NAME OF PROJECT: **Stor-Haus Self Storage**; Located approximately 315 feet northwest of the intersection of FM 2722 and Lone Oak Road; New Braumfels, Texas

TYPE OF PLAN: Request for Approval of a Modification of an Approved **Water Pollution Abatement Plan** (WPAP); 30 Texas Administrative Code (TAC) Chapter 213 Edwards Aquifer

Stor Haus Self Storage
Modification to a WPAP

Re: Review Comments Submittal per NOD dated 12/03/13
Modification to a WPAP
TCEQ File #: 2845.03
Stor Haus Self Storage

STOR-HAUS SELF STORAGE
BASIN DESIGN
WPAP MODIFICATION
1936 FM 2722, CITY OF NEW BRAUNFELS, COMAL COUNTY, TEXAS 78136
TCEQ-R13
MAR 10 2014
SAN ANTONIO

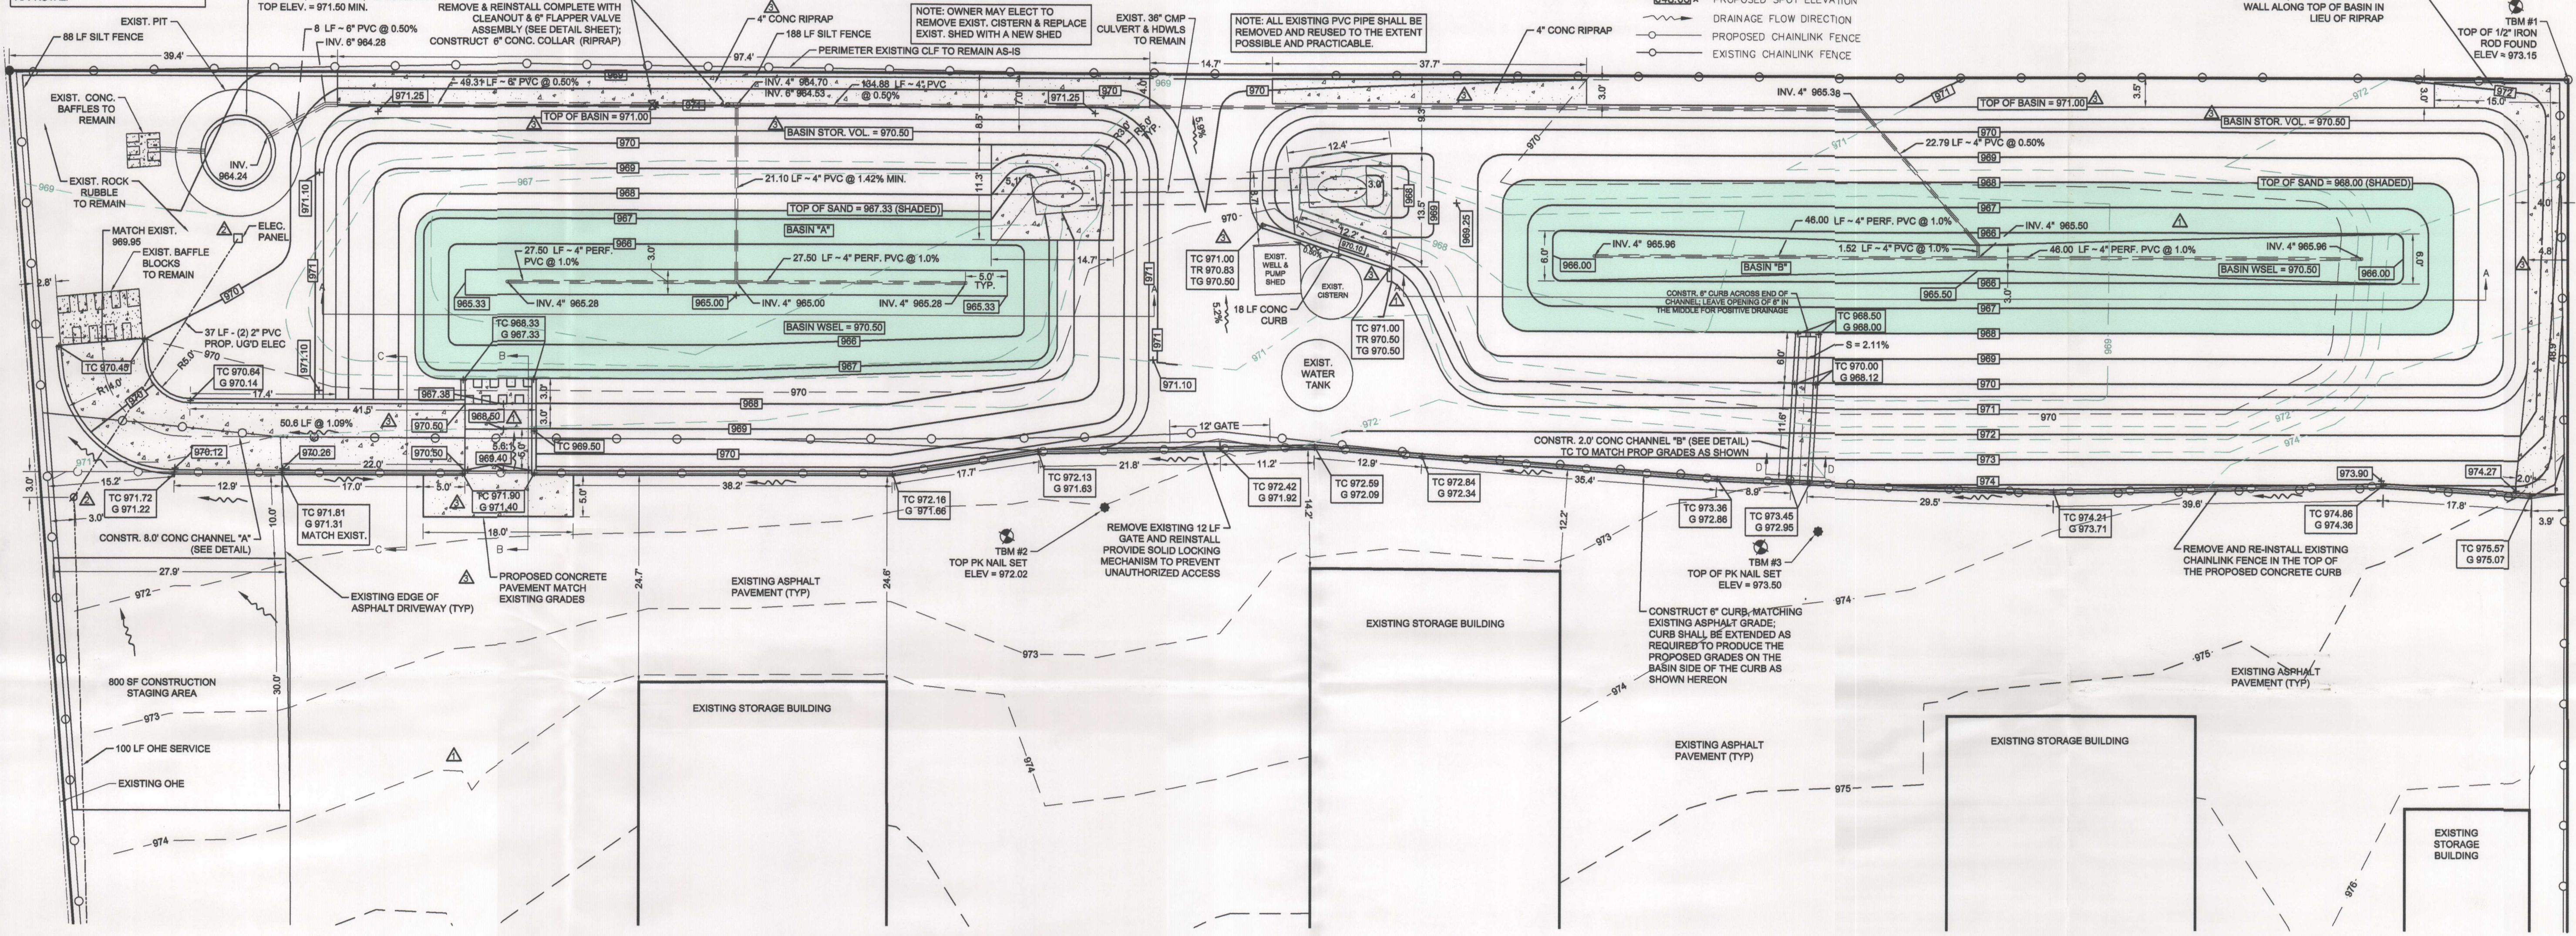
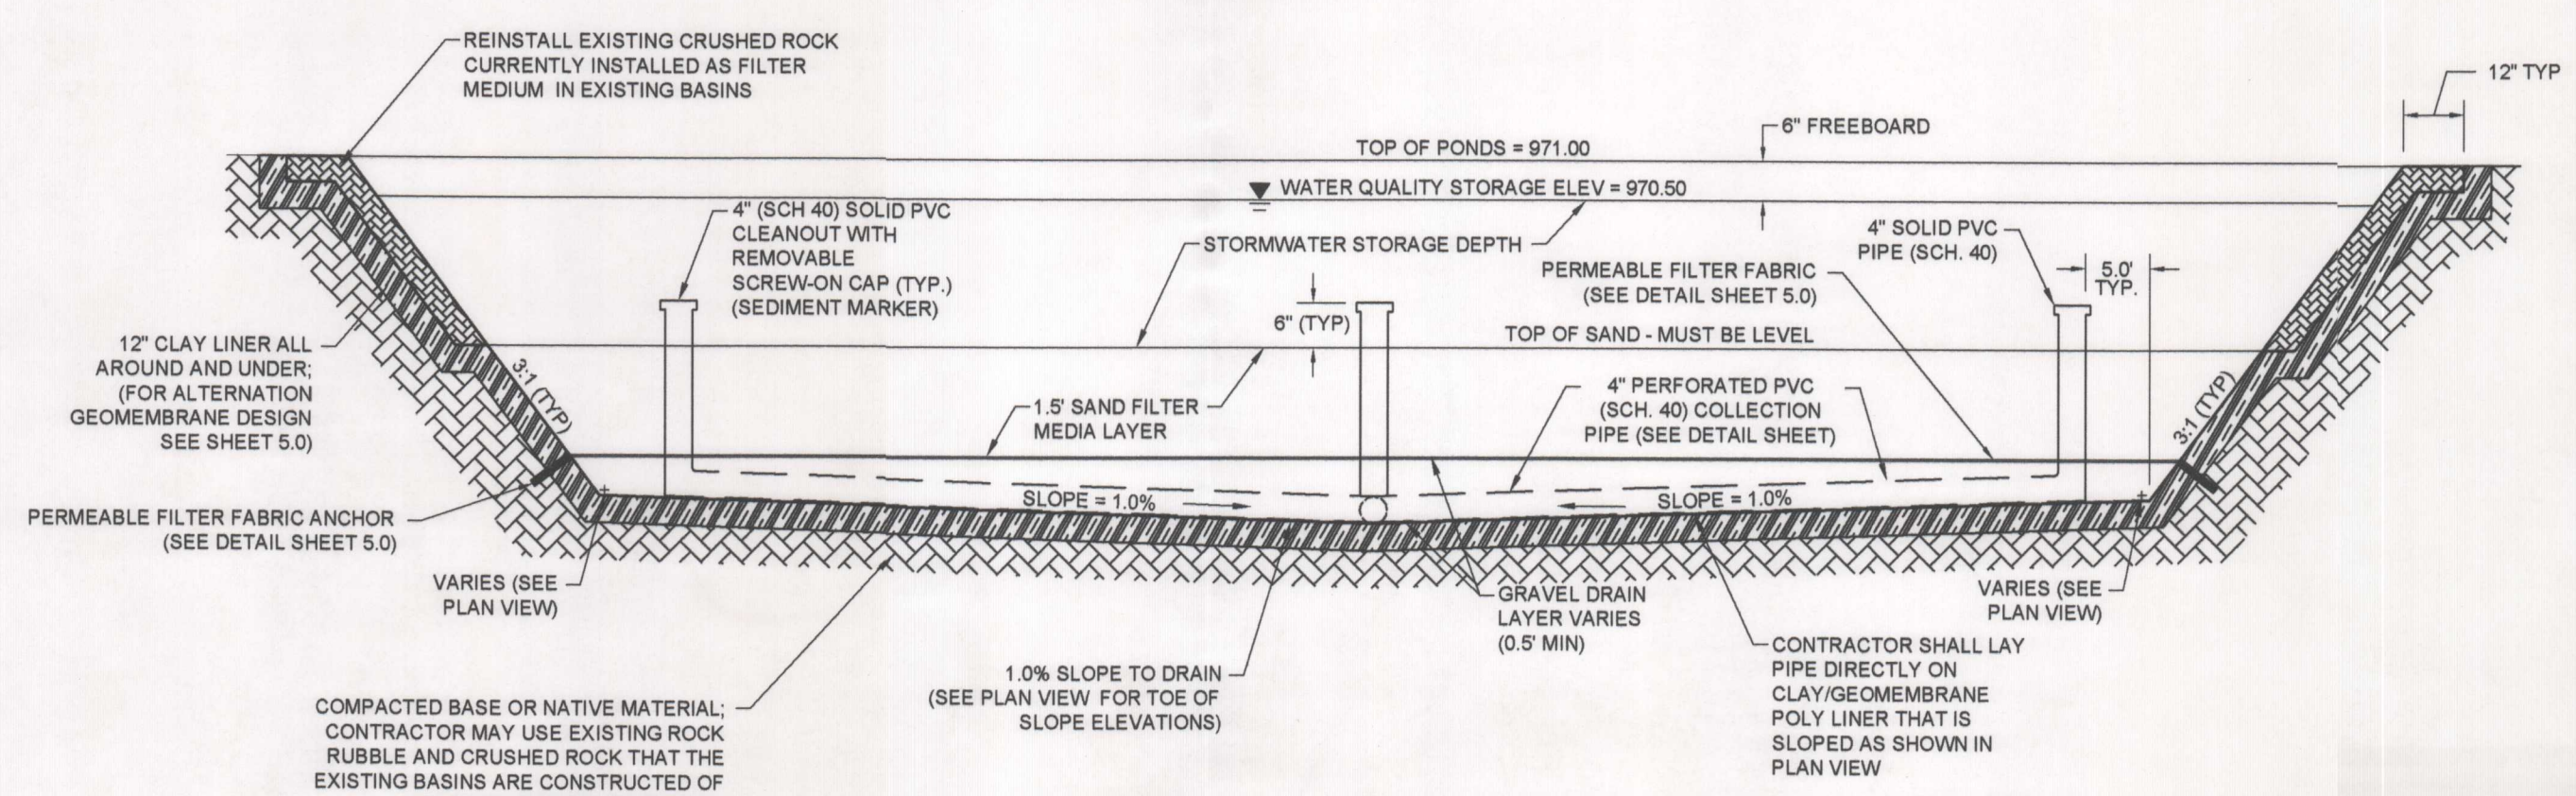
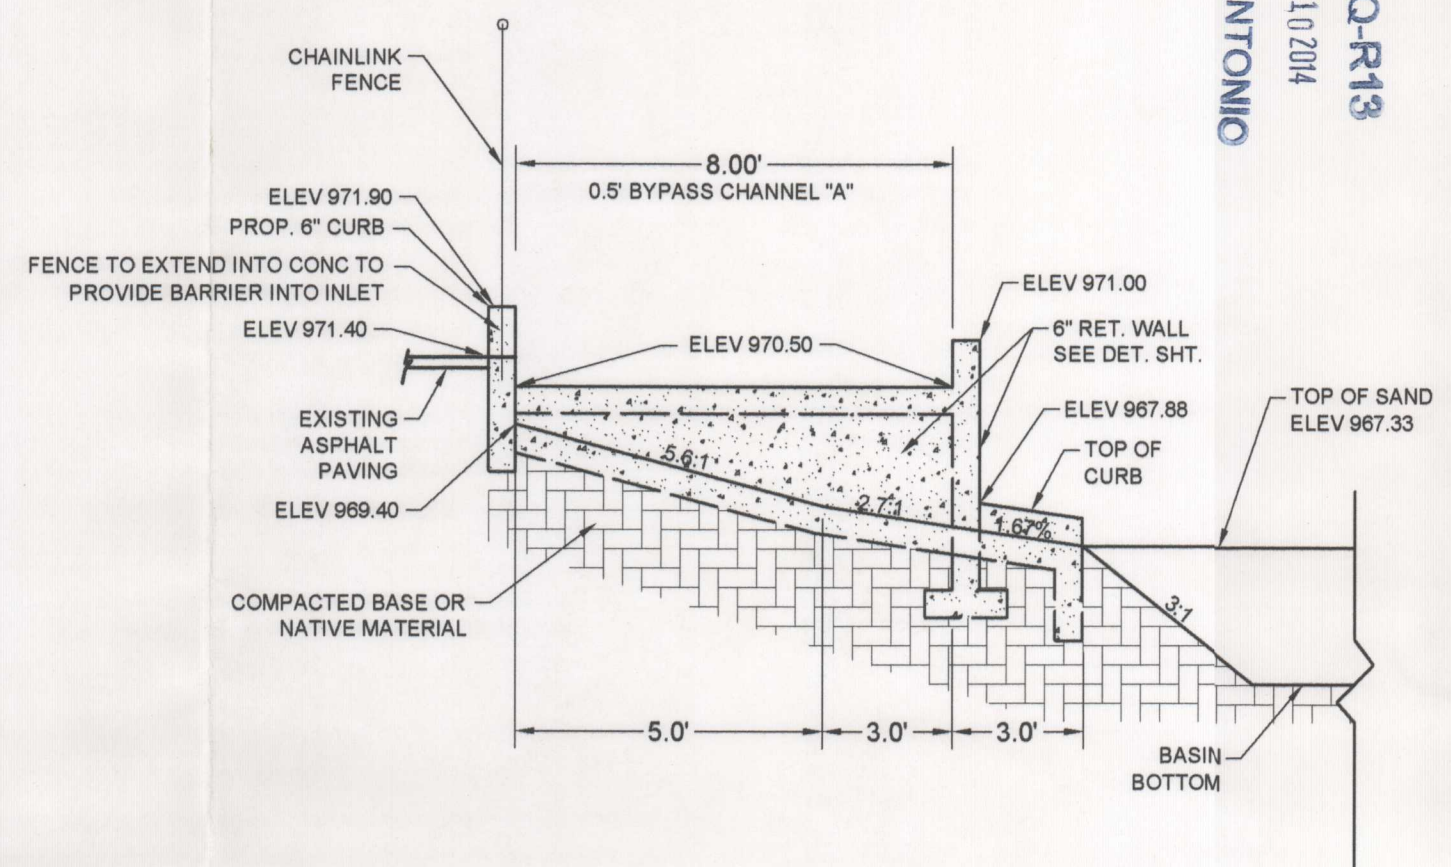
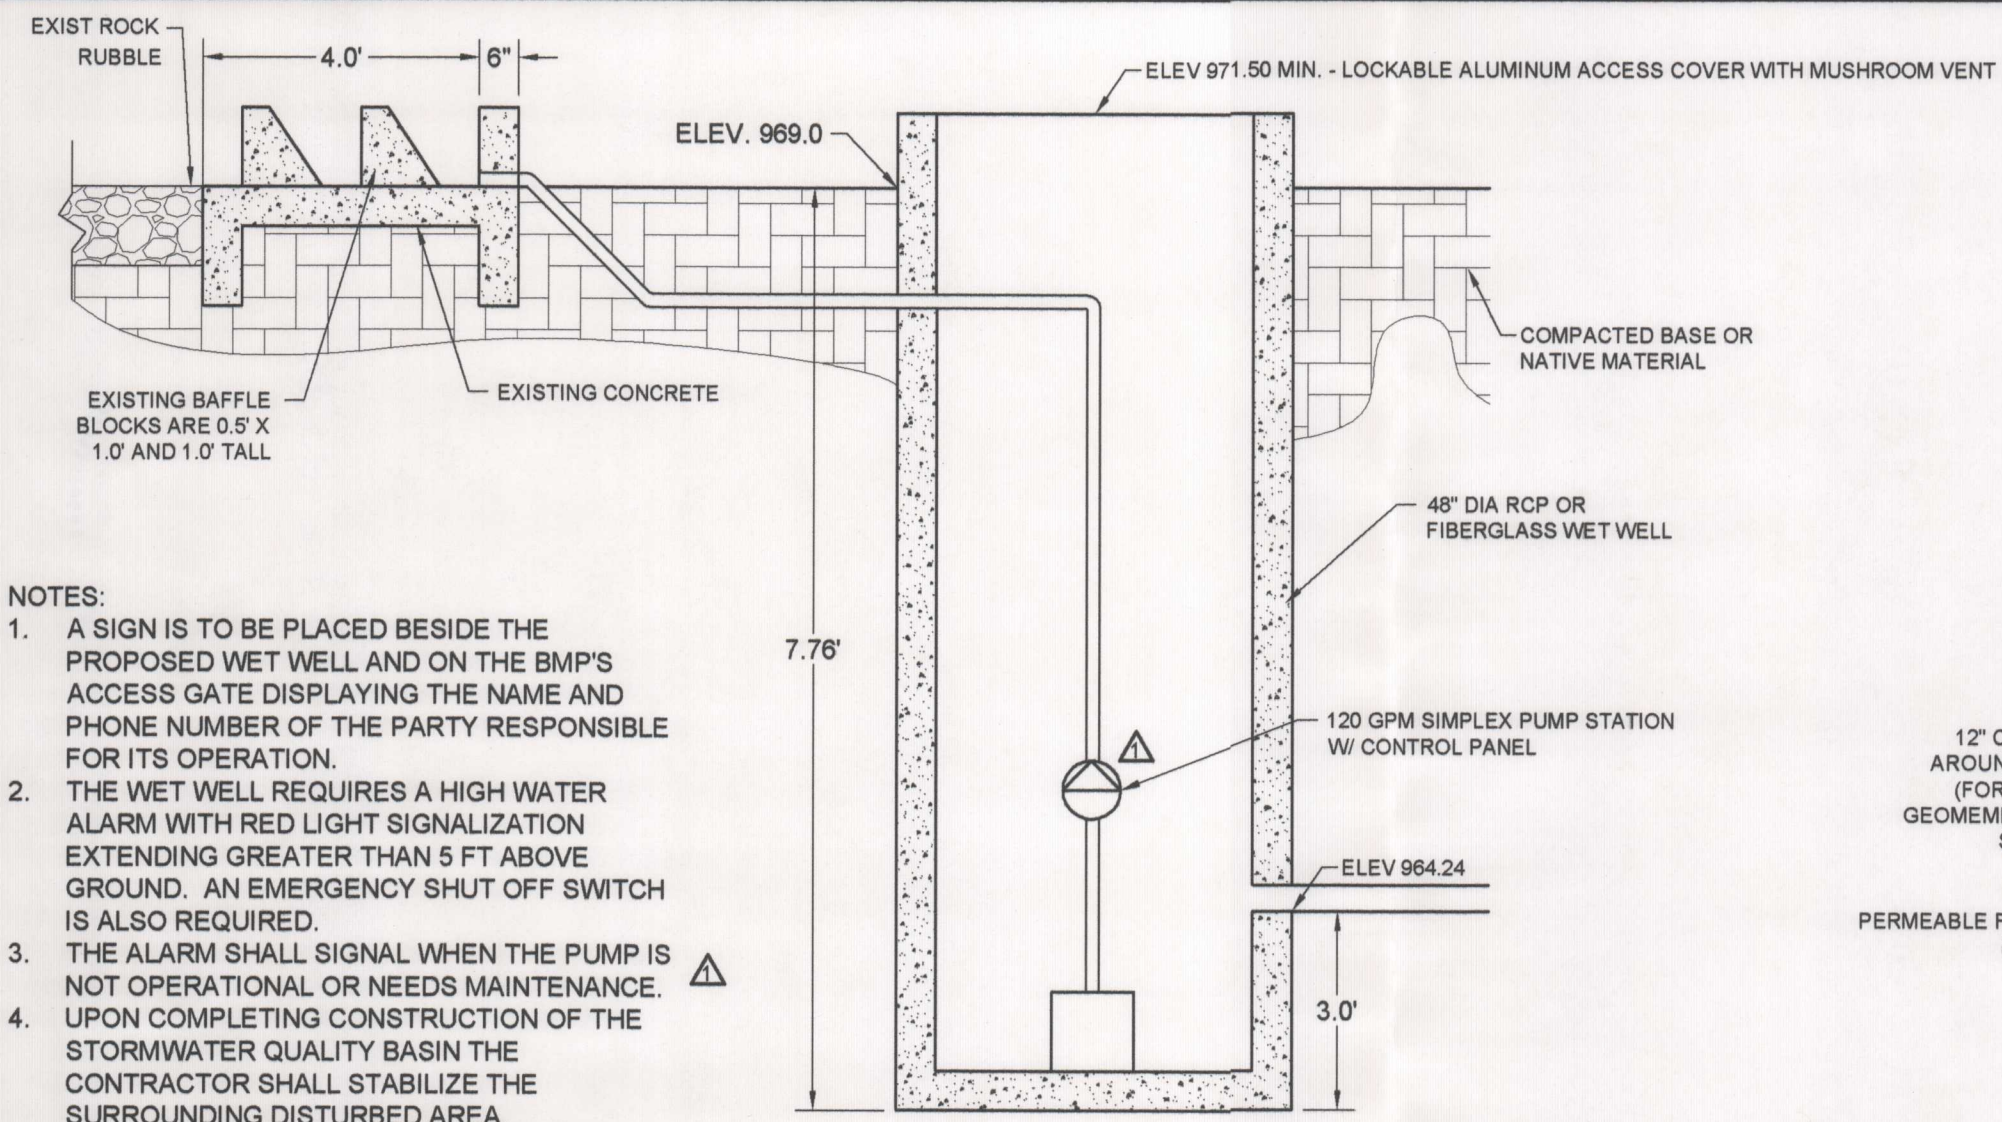
NO.	DATE	COMMENTS
1	08-15-13	BAFFLES, SAND HATCH BASIN SECTION, RISER PIPES, PUMP SYMBOL, ALARM.
2	11-05-13	TCEQ 00013 REVIEW COMMENTS, ELEC SERV.
3	03-10-14	REVISIONS TO BASIN PLAN, ELEC SERV. & REVISIONS TO CTRN NEAR MAIN INLET TO REFLECT NEW DATA FROM STAGING

PIPE DISCHARGE AT LINER DETAIL

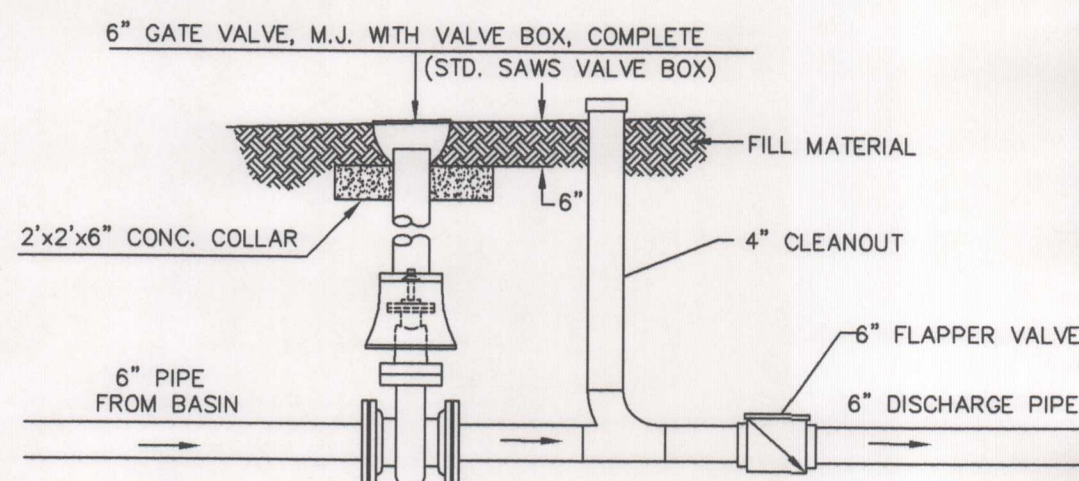
1. Added the geotextile fabric overlap to the table as requested (Sheet 5.0).
2. The clay impermeable liner has been added to the Pipe Discharge at Liner Detail (Sheet 5.0), as requested.
3. Raised cleanouts 6" above sand as requested (Sheet 4.0, Revision #2).
